**CNG FUELLING FACILITY, WATLING
STREET, HINCKLEY, LE10 3ED**

TRANSPORT STATEMENT ADDENDUM

**TRANSPORT STATEMENT ADDENDUM
ON BEHALF OF CNG FUELS LTD**

March 2024

Job No 22-240	Drawing No 22-240-007	Rev H
------------------	--------------------------	----------

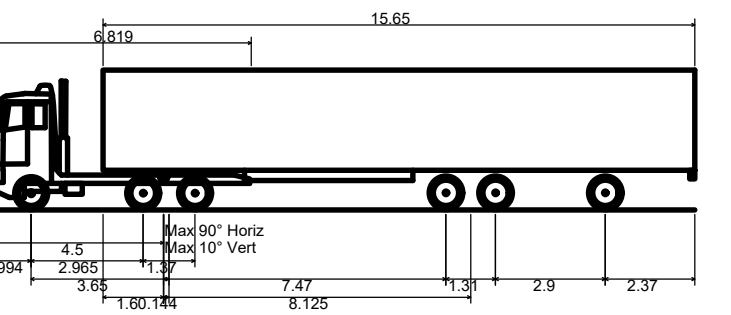
2.2.1 The previously submitted Transport Statement proposed a ghost island right turn lane priority junction on the A5 to provide all movements access into and out of the site. During the pre-application meeting LCC and NH Officers raised concern over vehicles routing from the site to the northwest via the existing low bridge on the A5. Specifically, Officers were concerned with a number of bridge collisions on the A5 and stated that further mitigation measures would be required to significantly reduce/ prevent Heavy Goods Vehicles (HGV's) from turning left out of the proposed site.

Drawing 22-240-002 Rev F demonstrates Swept Path Analysis (SPA) which has been undertaken for the site access. The SPA highlights that vehicles travelling into and out of the site could leave to potential conflict with other vehicles.

2.2.2 Based on the comments received from LCC and NH Officers during the pre-application meeting, a revised access solution has been developed. The revised access proposes a left in, right out only arrangement (see attached **Drawings 22-240-007** and **22-240-008**). The revised access arrangement has been designed to prohibit vehicles from turning right into the site from the A5 via the use of a curved central island within the access road, which would physically prevent HGV's from making a right turn onto Watling Street.

2.2.3 The proposed access arrangements presented in **Drawing 22-240-007** would also prohibit and physically prevent vehicles from egressing left out of the site onto the A5 as there would be no kerb radii to allow for this. Instead, a small bullnose kerb with HGV bollard and/ or trief kerb would be provided where the proposed access ties into the A5. All vehicles egressing the site would instead be routed southeast towards the Hammond's Way roundabout, directly away from the A5 railway bridge.

2.3.4 The visibility splays are shown on the revised access **Drawing 22-240-007**. As shown on the drawing, the visibility splays do not extend beneath the railway bridge to the west and nor does the splay extend across the existing BP access to the east.

- We have redesigned the site access from the previously proposed ghost island arrangement to a left in, right out only priority junction. The priority junction has been designed to ensure that HGV's would not be able to turn left out of the proposed site and travel towards the bridge on the A5. Please see attached **Drawing 22-240-007** which shows the now proposed site access.

- As **Drawing 22-240-007** shows, the visibility splays from the proposed access do not crossover the adjacent access for the BP garage, nor do they go beneath the existing A5 bridge. These visibility splays have been determined using the results of an Automatic Traffic Counter (ATC) survey carried out on the A5 using an independent survey company. The results of the ATC survey are attached for review and will be submitted as part of the forthcoming Transport Statement Addendum. Given that the visibility splays would not cross over third-party land, we do not believe that a departure from standards would be required.
